Change Orders

April 28, 2017

Phase 2 – Crossland Construction Company

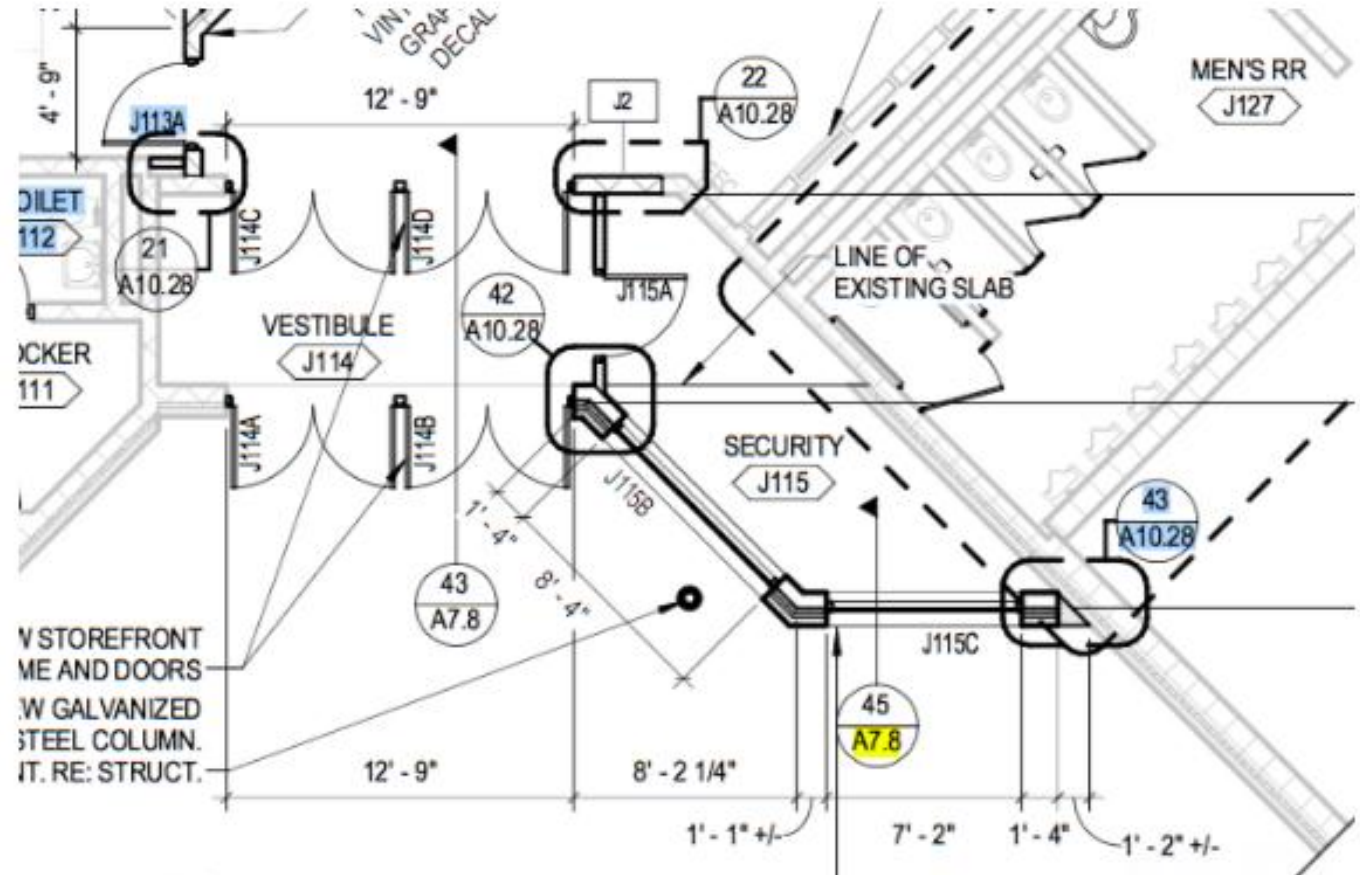
- **COR 21 – Security Office**
- Can meet need without office addition
- Savings of \$18,660
